SERVICE BULLETIN

DATE: 12-21-2010 **BULLETIN NO:** 10-011A
REVISED: 1-20-2011

TITLE: LOW HYDRAULIC RESERVOIR FLUID LEVEL SHUTDOWN

PRODUCT SERIES / MODEL: All RGH10C1-45 / 46 Rail Grinders
All RGH10C2-36 / 37 Rail Grinders

FIGURE 1
RGH10C1-45 / 46 SWITCH S1630

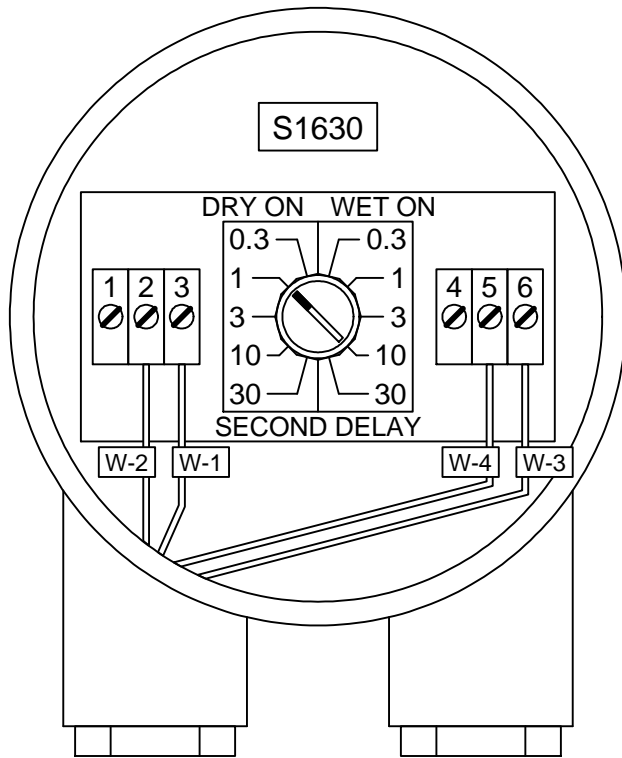
1. Make sure the master disconnect switch is shut off. The master disconnect switch is located on the right side of the machine towards the rear of the dust collector.
2. The low hydraulic fluid level switch (S1630) is mounted on the top of the hydraulic reservoir as illustrated in Figure 5. Unscrew the cap from the top of the switch and inspect the current wiring of the switch. There should be a wire from the cable connected to terminals 2, 3, 5 and 6 as follows and as illustrated in Figure 1 or 2. If needed, rewire the cable.

4. Verify the internal settings of the low hydraulic fluid level switch (S1630) match the settings of the switch as illustrated in Figure 1 or 2. If needed, set the dial to "Dry ON" at "1 Second Delay". Then re-install the cap on the top of the low hydraulic fluid level switch (S1630).

Terminal 2 - Wire 2 - 000 From TB 30-59)
 Terminal 3 - Wire 1 - 1660 From TB 32-20)
 Terminal 5 - Wire 4 - 941 From TB 32-14)
 Terminal 6 - Wire 3 - 914 From TB 32-13)
